# UNITED STATES PATENT AND TRADEMARK OFFICE

APPLICATION NO.	FILING DATE	FIRST NAMED INVENTOR	ATTORNEY DOCKET NO.	CONFIRMATION NO.
10/775,922	02/10/2004	Michael F. McAllister	POU920020057US2	1394

**Office Action Summary**

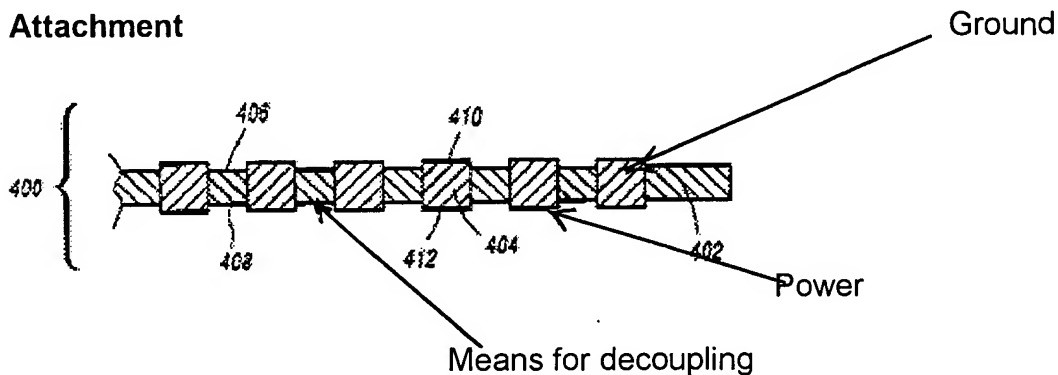
Claim 1 is rejected under 35 U.S.C. 102(e) as being anticipated by Tamarkin et al. (6,428,327).

As best understood, Tamarkin et al. disclose Land Grid Array structure (see Fig. 5A - 8) comprising:

a flex film interposer 400/or 500 for providing electrical connection disposed between a Multi-chip (MCM) 312 and the next level of integration of a LGA system 314 (board with pads), and the flex film 402 or 502, wherein the interposer 400/500 also provides means integral to the flex film interposer 400/500 (see Fig.5A) for implementing a

desired Engineering Change (EC) (such a wire end 336, which provided for connection to the external circuit, or it can be every change in size of a board), and the flex film interposer 400/500 also integrally provides means for decoupling power to ground in the Land Grid Array structure to minimize switching activity effects on the Land Grid Array system when mounted on a system board 314 (see Attachment).
